LIGO-E1900223-v1

Review Report
Design Requirements and Concept
for the A+ ISC Filter Cavity and
Relay Optics

Valery Frolov, Sheila Dwyer, Adam Mullavey, Koji Arai, Daniel Sigg (chair)

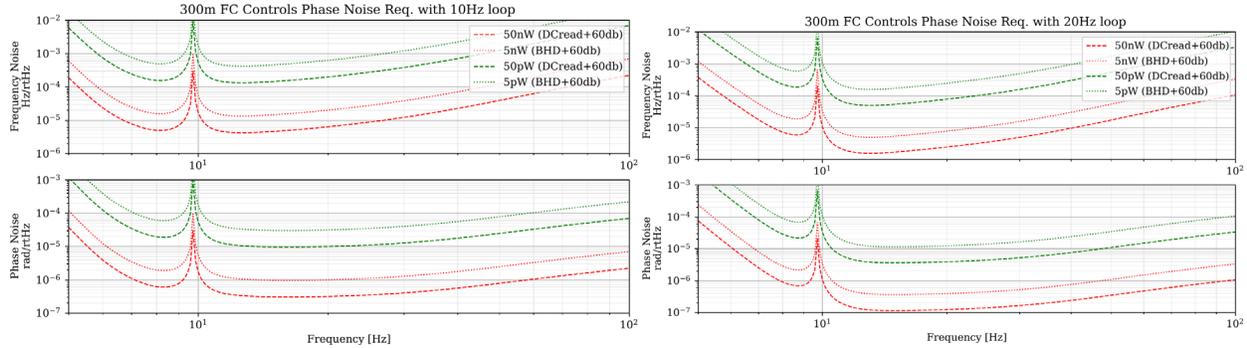
DS: I am still trying to follow the 10^{-6} rad/ $\sqrt{\text{Hz}}$ of phase noise requirement. Sect 8.2 in T1800447 talks about 120dBc at 100Hz falling like $1/f$, which translates into 10^{-4} Hz/ $\sqrt{\text{Hz}}$ flat. This in turn corresponds to a length requirement of 10^{-15} m/ $\sqrt{\text{Hz}}$. So, do figures 10 and 11 show a flat sensing noise of 10^{-4} Hz/ $\sqrt{\text{Hz}}$? In other words, is the phase noise requirement at 10Hz 100dBc?

Lee: I doubled checked how I was calculating it and I believe you are right. I chose some convoluted wording and a reference frequency of 100Hz. Indeed the requirement is the much more reasonable $1e-5$ rad/ $\sqrt{\text{Hz}}$ at 10Hz (100dbc), corresponding to $1e-4$ Hz/ $\sqrt{\text{Hz}}$. I'll update the DRD first thing next week. Maybe we can have only 2 Faradays after all.

Lee-later: here are the requirements plots based on the reference control implementation in T1800447. This is the acceptable noise level in units of sensing phase noise

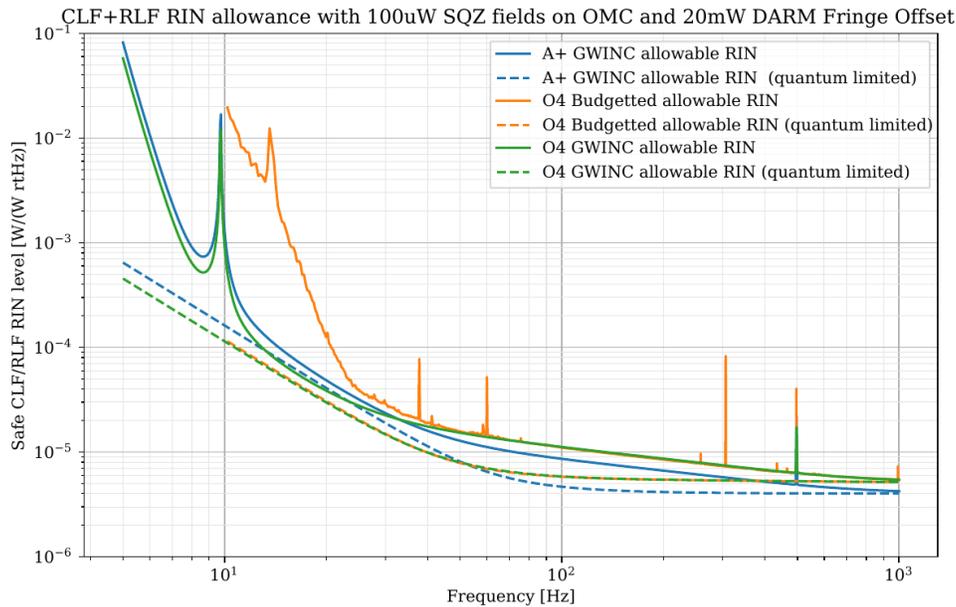
Are there requirements for the intensity stabilization of CLF and pump? I can't find anything in T1800447. Using intensity noise numbers from the laser may be too optimistic, see [alog 45088](#).

If you look at the green pump power as measured in reflection and in transmission, there is not much correlation for frequencies < 10 Hz. Jitter? See [alog 48363](#).

We only have 325 nW of green in transmission. So, the sensing noise is expected to be $\sim 2 \times 10^{-6}$ RIN/ $\sqrt{\text{Hz}}$. This level is reached around ~ 30 Hz. This is all somewhat miserable, and I am wondering, if we need a new M2 mirror for the OPO with a green transmission between ~ 1000 - 3000 ppm. This would increase our transmitted OPO power by 300 - 1000 , and improve the sensing noise by ~ 20 .

Lee: I have not computed/documented requirements yet for the CLF and pump. The CLF should be somewhat straightforward, but the pump may be more difficult.

Figure 1 RLF/CLF locking signals.

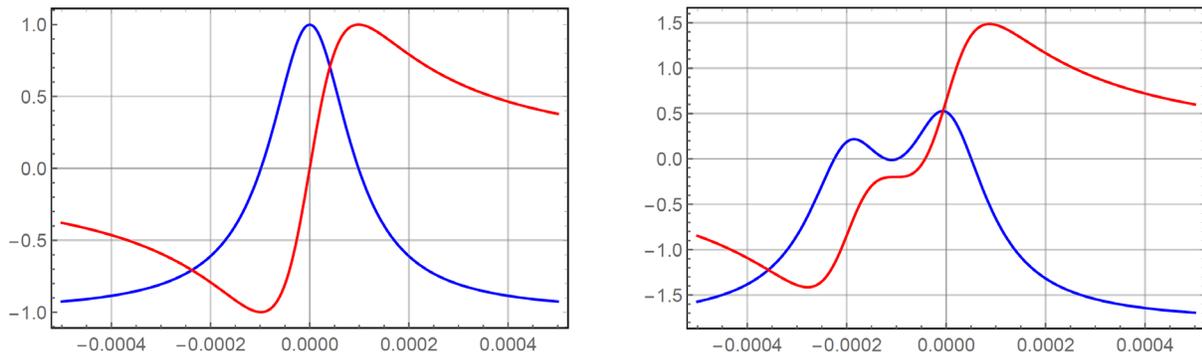
I was looking at your fig 2 in T1900416. It shows the squeeze field detuned in the FC, the RLF+ resonant and the RLF- detuned by 2 cavity pole frequencies. In the current scheme, the FC error signal would be RLF+ beating against CLF+, but RLF- against CLF- would generate a signal too. Since they are detuned, this signal isn't very helpful. Doing some math the RLF- will acquire about 126 degree of phase shift, which yields a PDH signal that is about 80% of max. This seems bad.

The figure on the left below shows the error signal in I and Q generated by the RLF+ and CLF+ beat, when the RLF is resonance. Basically, a single sideband type of PDH where the Q signal peaks on resonance. The figure below on the right shows basically the same but I am adding the RLF-/CLF- beat note detuned by 2 FC-pole. RLF-/CLF- have 80% of the RLF+/CLF+ amplitude.

Have you considered a scheme where the RLF+ has the same detuning as the squeeze field? Then, RLF- would also have the same detuning and produce exactly the same signal (\pm some RF phase delay due to the 6MHz difference).

Lee: OK, I see what you mean. Indeed the error signal is a bit nasty in the existing 2-pole-detune scheme, so I favor the 1-pole balanced scheme.

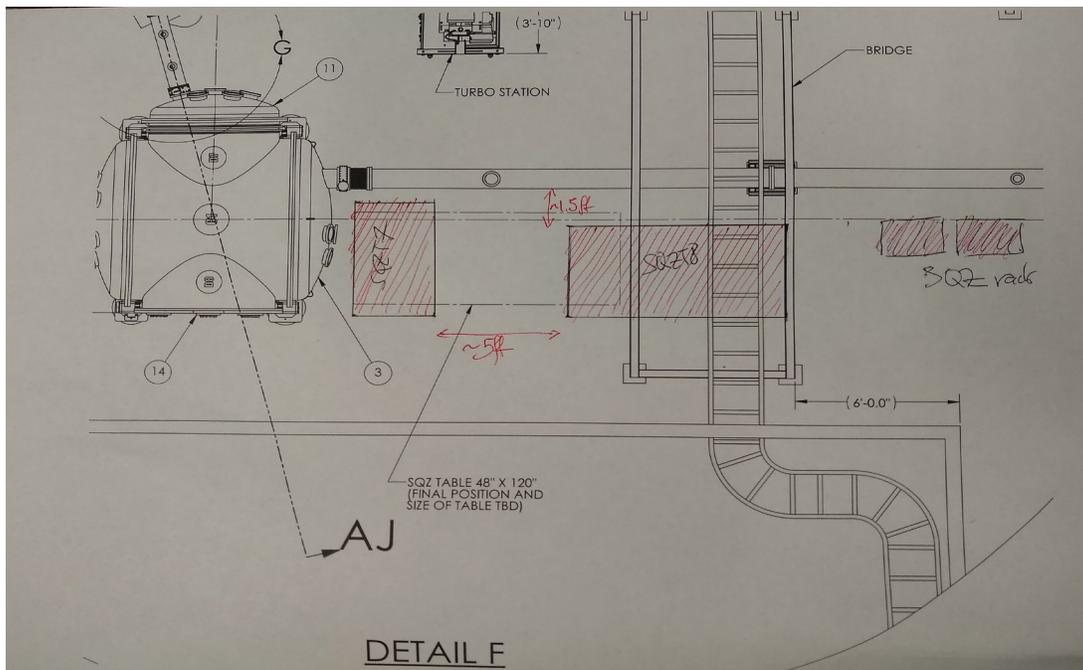
15. DS: Where will the current ISCT6 be located?

Does ISCT6 move? At least some of the drawings show it behind HAM7 towards BSC3.

Lee: The table will be moved to +Y. The current sketch shows them at [D1800027](#).

The fiber-side of the table will be closer to HAM7, laser side +y to reduce the length of the fiber-runs. The location of SQZT7 will require its layout to be mirrored, but ISCT6 shouldn't need changes.

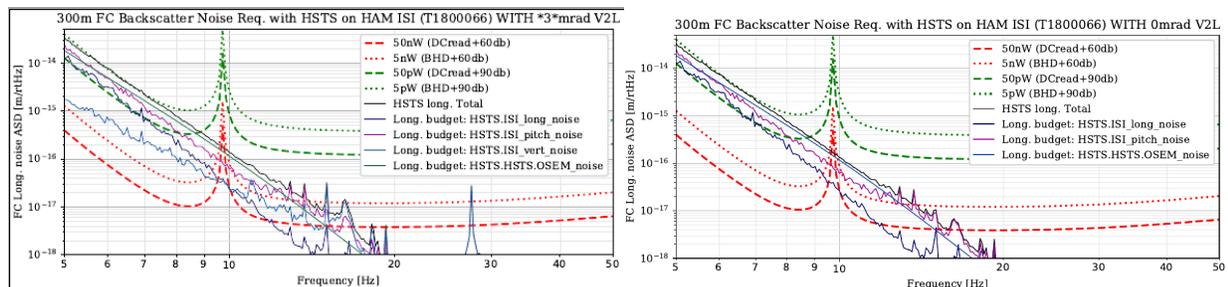
Related to Sec 1.3.5 “OMC DCPD Response at 3.125 MHz”, the cavity pole of the current OMC is 300kHz, and thus the CLF is significantly attenuated at the transmission. Combined with the PD response mentioned in Sec 1.3.5, is there a possibility to lower the CLF frequency?

Lee: We could but would need to measure the phase/RIN spectrum of the laser more carefully to make sure it is clean enough at any lower frequency.

DS: If you use a pick-off to deduce the FC error signals, the argument reverses. With a higher frequency, you would be able to increase the CLF power without adding more noise after the OMC. The note about the photodetector readout is true, but it would be better to improve the readout.

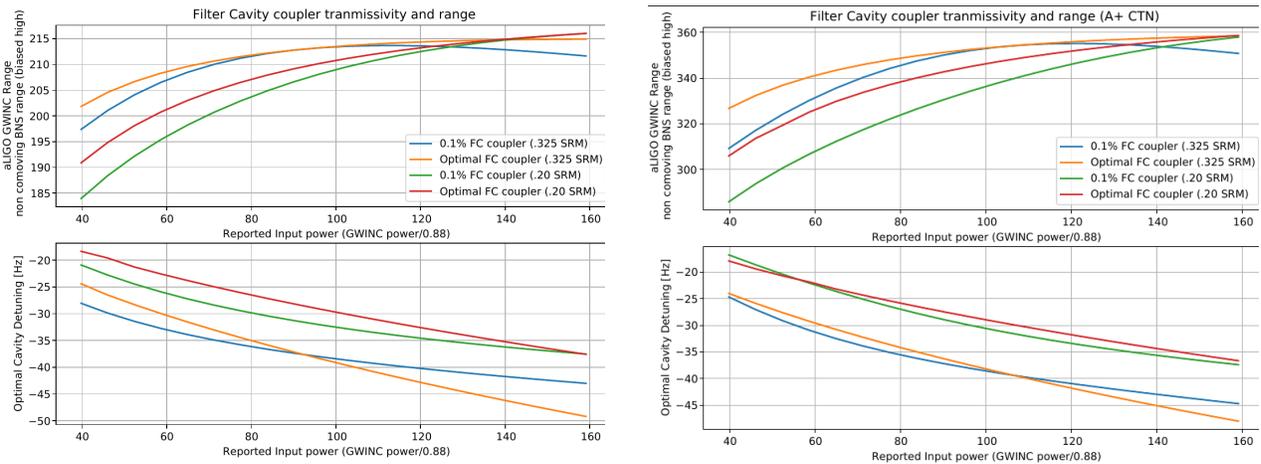
Angle of incidence: the path length change from a single pass off a relay mirror should be $2*\Delta L/\cos(\theta)$, which is almost a factor of 3 for 45 degree incidence. Is this included? Also, there is a sentence in section 6.5.1 "For the OPOS, this can be mitigated somewhat by adjusting the input and output angles to have an effectively large angle of incidence". I think a larger angle of incidence means that the same suspension motion would cause more phase modulation, and it also seems like a small benefit in terms of backscatter wouldn't be worth the mechanical and aperture problems that could arise.

Although each of these three quibbles is small, if each one of them is added on top of what is done in this document they would make the requirements stricter by a factor of 10, which seems serious.

Lee: No, all relay mirrors are calculated against $4\pi/\lambda / \sqrt{2}$. The $\sqrt{2}$ is the point above. 4 of the 6 relays in the optical layouts are very near 0 AOI. The current layout is not using any tricks to improve relay phase sensitivity.

Lee: Yes, although 3-4 of the relays will very likely be the new ham double SUS (HDS) to be wavefront control-compatible. Those will have lower noise at 10 Hz. It will be worthwhile and reasonable to combine the plots to model our currently chosen implementation with these multiplicity and coherence increases in the noise.
